BOWIE LOTS TCP II OVERVIEW									
SHEET	# LOTS IN THE R-R ZONE	# PARCELS IN THE R-R ZONE	# LOTS IN THE R-55 ZONE	R-R AREA (AC.)	R-55 AREA (AC.)	OWNERSHIP	# LOT SITED	100 YR. FP.	
1	27		5	5.94	0.92	OWNED	3		
2				7.37		OWNED	28		
3			53		4.25	OWNED	6	0.4	
4		3	15	4.92	0.88	NOT OWNED	0		
5	23			3.21		OWNED	12	0.65	
6	0			0.33		OWNED	0		
TOTAL	77	3	73	21.77	6.03	OWNED	73	1.05

Prince George's County Planning Department, M-NCPPC				
Environmental Planning Section				
TREE CONSERVATION PLAN APPROVAL				
TCP2-170-04				
	Approved by	Date	DRD #	Reason for Revision
00	LORI SHIRLEY	2/3/04		
01	*LORI SHIRLEY	10/04/05		
02	K.S.	04/12/10		
03	KIM FINCH	01/28/15		
04	KIM FINCH	10/14/2021		
05	Kim Finch	3/30/2024	NA	Block 26, Lot 62-70, 57-60
06				
Woodlands preserved, planted or regenerated in fulfillment of woodland conservation requirements on-site have been placed in woodland and wildlife habitat conservation easement recorded in Prince George's County Land Records at Liber ___, Folio ___. Revisions to this TCP2 may require a revision to the recorded easement.

BOWIE LOTS
HUNTINGTON CITY
BOWIE (4th) ELECTION DISTRICT
PRINCE GEORGE'S COUNTY, MARYLAND

COVER SHEET
TCP II

SHEET NO. 1 OF 5

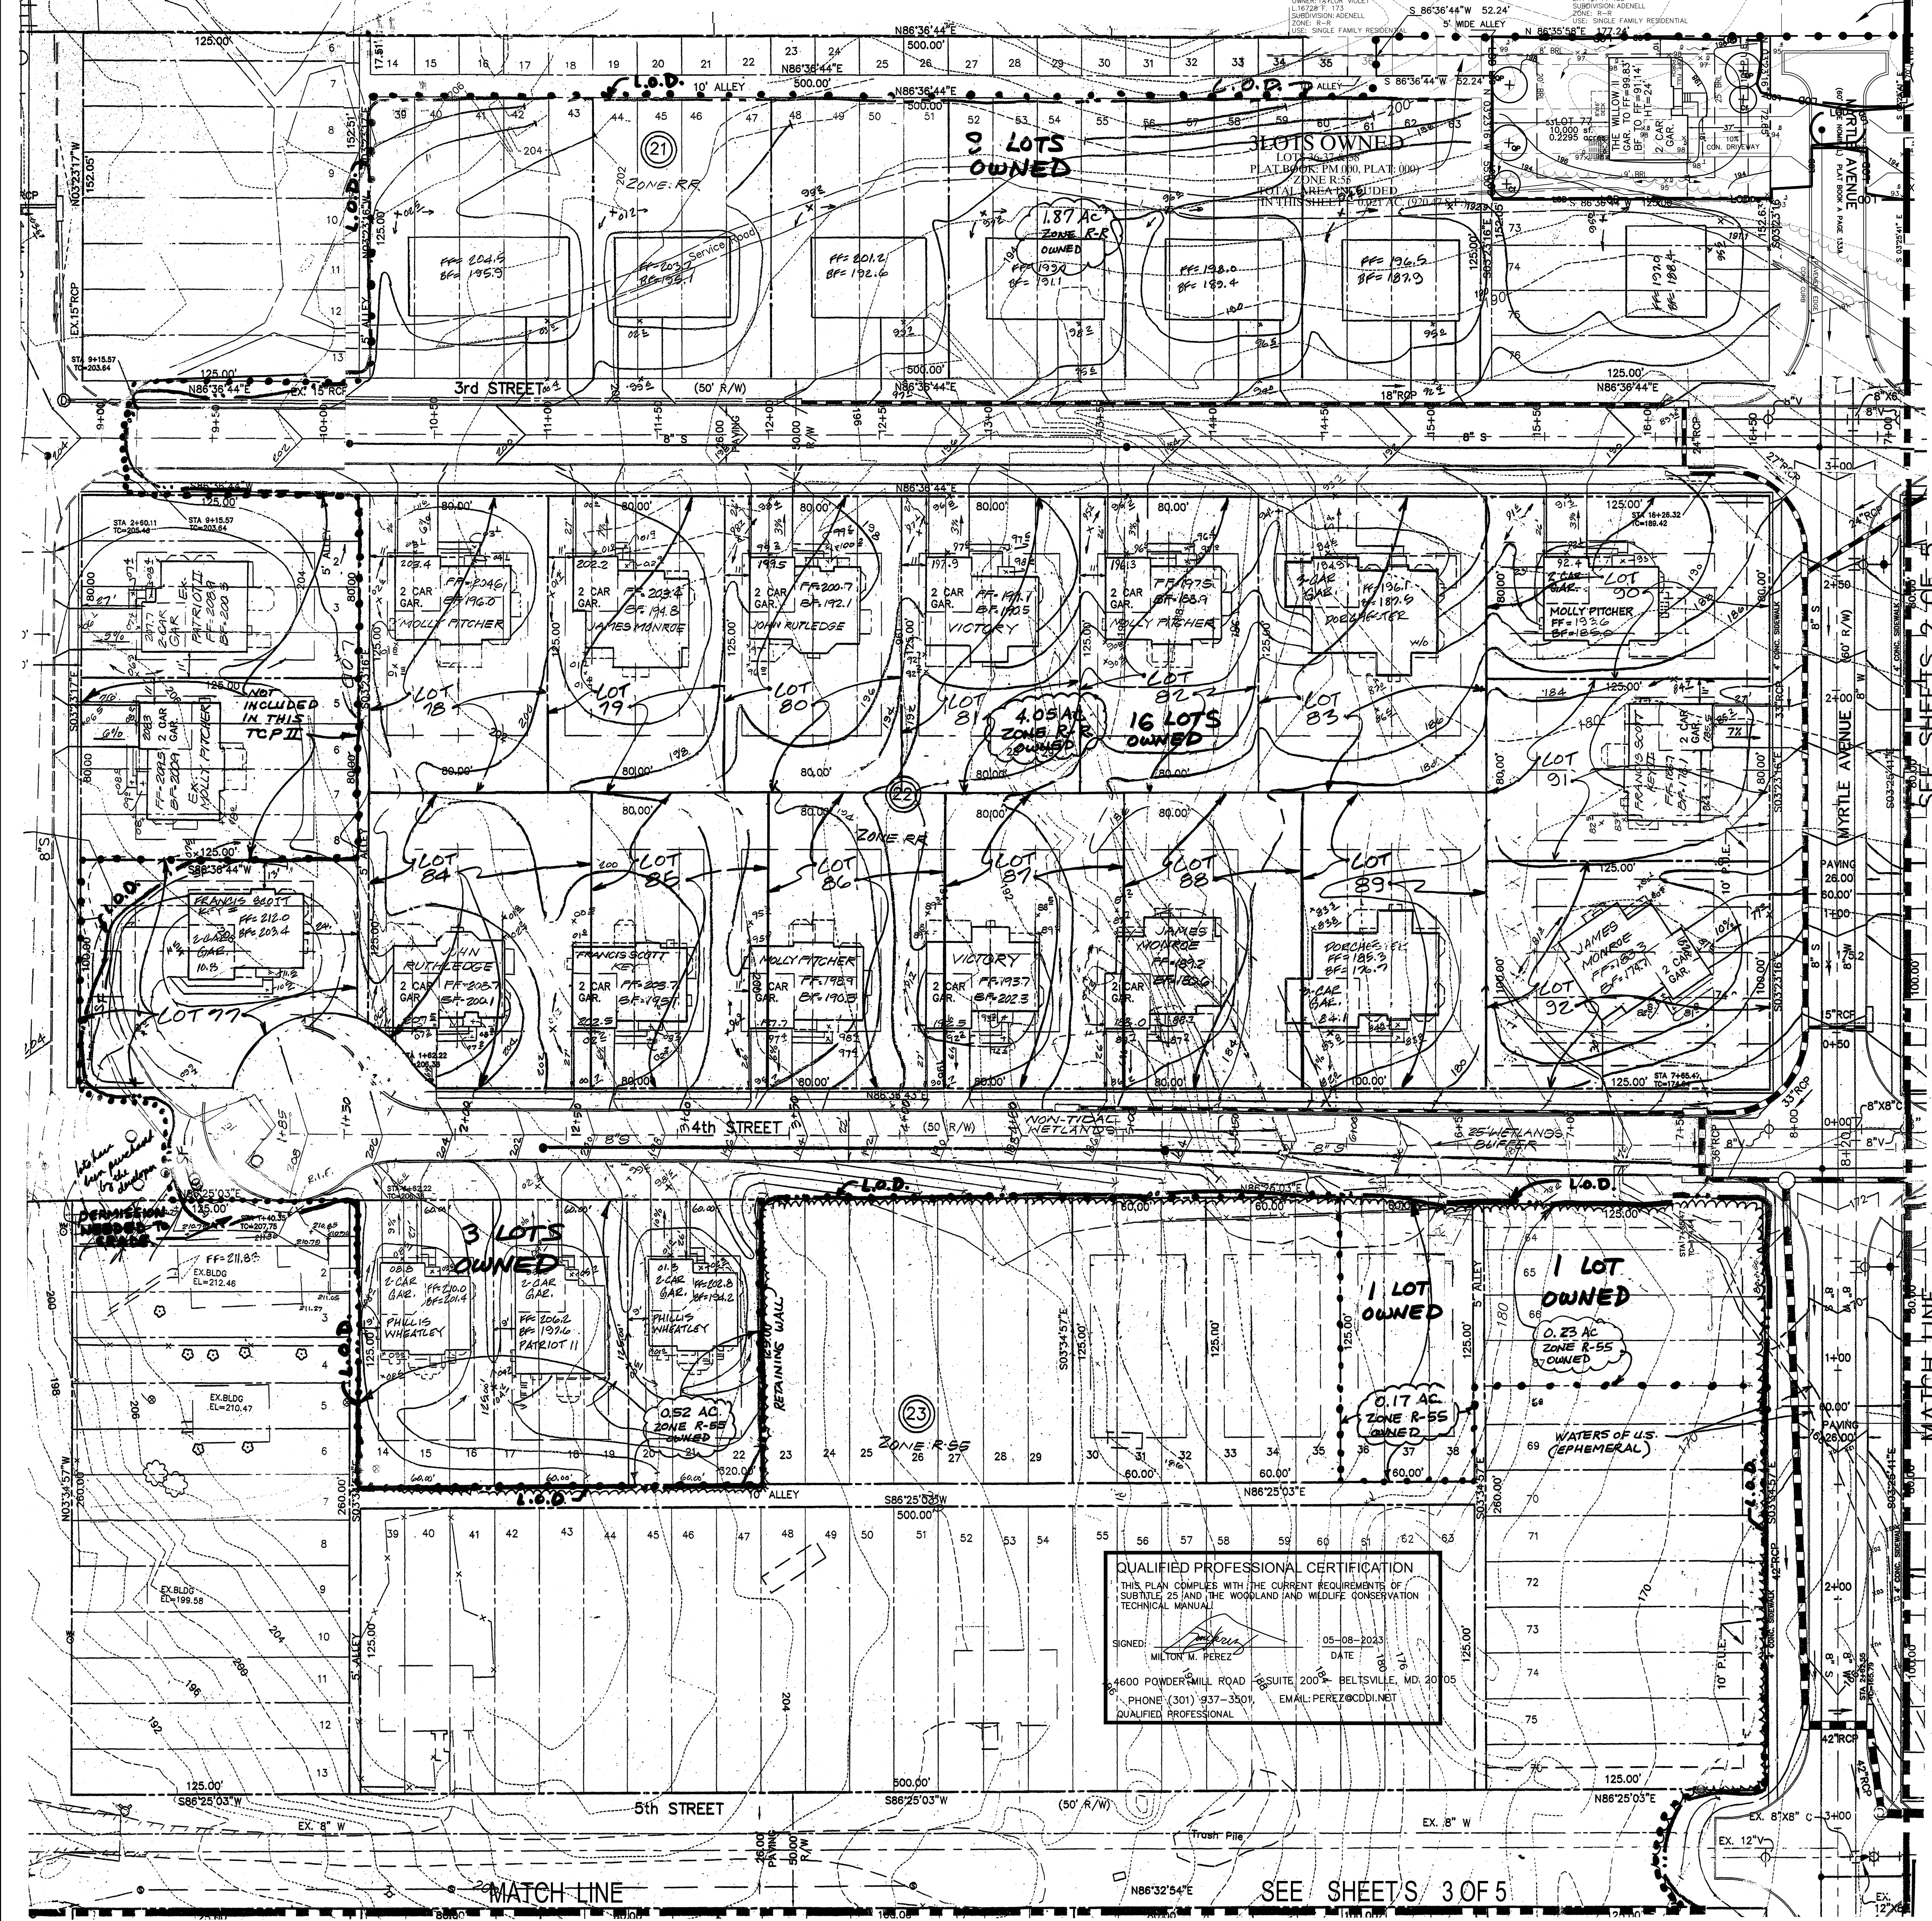
* 8/23/05: THIS SHEET WAS REVISED TO INCLUDE 1 ADDITIONAL BUILDING LOT, NOT PREVIOUSLY INCLUDED IN THE OVERALL CALCULATIONS FOR THIS SHEET. ALSO, THE 29 BOWIE LOTS WHICH WERE INCLUDED IN THE PREVIOUSLY APPROVED PLAN DATED 2004, BUT NOT OWNED AT THAT TIME (INCLUDED FOR GRADING PURPOSES ONLY) ARE NOW OWNED AS 7 BUILDABLE LOTS. THE TOTAL NEW BUILDABLE LOTS FOR THIS REVISION = 6. IN ADDITION TO THESE 6, 1 BUILDABLE LOT, PREVIOUSLY SITED, IS NO LONGER PLANNED FOR BUILDING DUE TO WULS. ISSUE. THE AMOUNT OF CLEARING HAS BEEN REDUCED FOR THIS AND THE SITED HOUSE HAS BEEN REMOVED.

*212/13/13 THIS REVISION INCORPORATES THE RESUBDIVISION OF FORMER LOTS: 69, 70, 71, 72 BLOCK 21 AND LOTS 36, 37, 39 BLOCK 21 FOR LOT 77 (PLAT: RECORDATION IN PROCESS, BOOK PM: RECORDATION IN PROCESS). THIS SHEET FULFILLED THE WOODLAND CONSERVATION REQUIREMENTS OF SHEET 5 OF 5.

*04/6/10 THIS 0.021 AC. ADDITIONAL AREA COMES FROM LOTS 36, 37, 38 AND AND 5' ALLEY.

SHEET NO. 2 OF 5

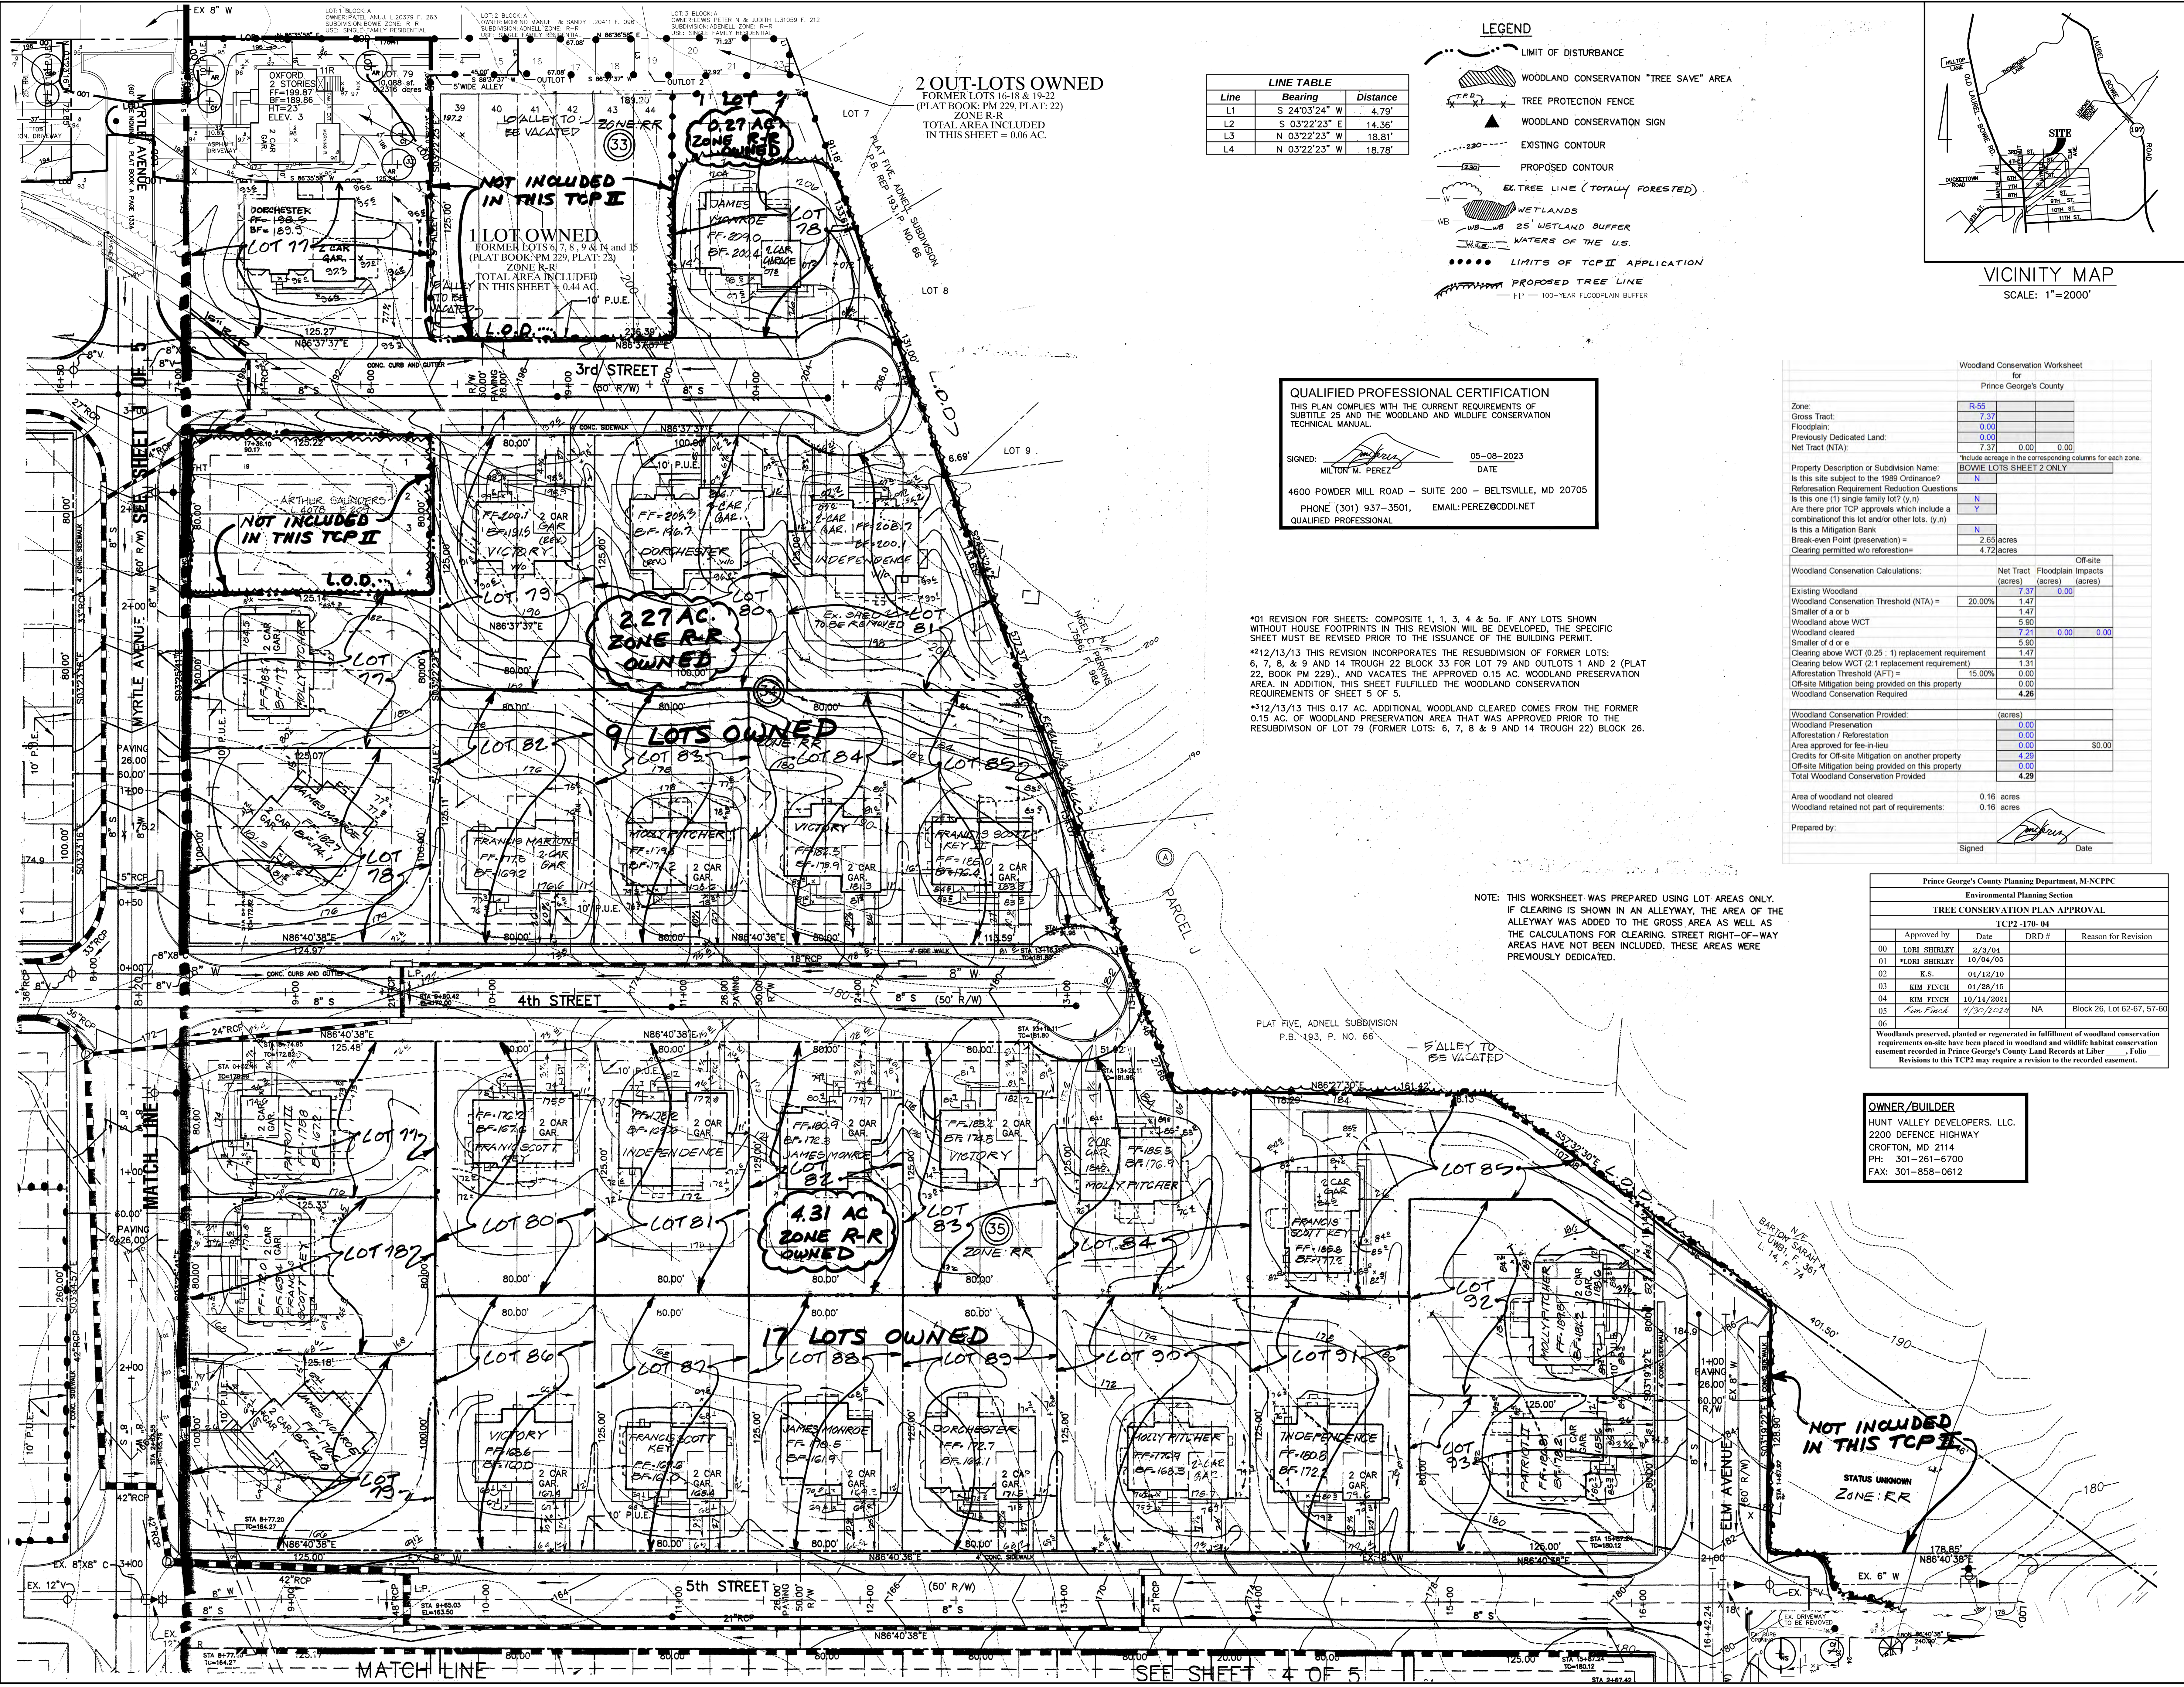
- *01 REVISION FOR SHEETS: COMPOSITE 1, 1, 3, 4 & 5a. IF ANY LOTS SHOWN WITHOUT HOUSE FOOTPRINTS IN THIS REVISION WILL BE DEVELOPED, THE SPECIFIC SHEET MUST BE REVISED PRIOR TO THE ISSUANCE OF THE BUILDING PERMIT.
- *212/13/13 THIS REVISION INCORPORATES THE RESUBDIVISION OF FORMER LOTS: 6, 7, 8, & 9 AND 14 TROUGH 22 BLOCK 33 FOR LOT 79 AND OUTLOTS 1 AND 2 (PLAT 22, BOOK PM 229), AND VACATES THE APPROVED 0.15 AC. WOODLAND PRESERVATION AREA. IN ADDITION, THIS SHEET FULFILLED THE WOODLAND CONSERVATION REQUIREMENTS OF SHEET 5 OF 5.
- *312/13/13 THIS 0.17 AC. ADDITIONAL WOODLAND CLEARED COMES FROM THE FORMER 0.15 AC. OF WOODLAND PRESERVATION AREA THAT WAS APPROVED PRIOR TO THE RESUBDIVISION OF LOT 79 (FORMER LOTS: 6, 7, 8 & 9 AND 14 TROUGH 22) BLOCK 26.
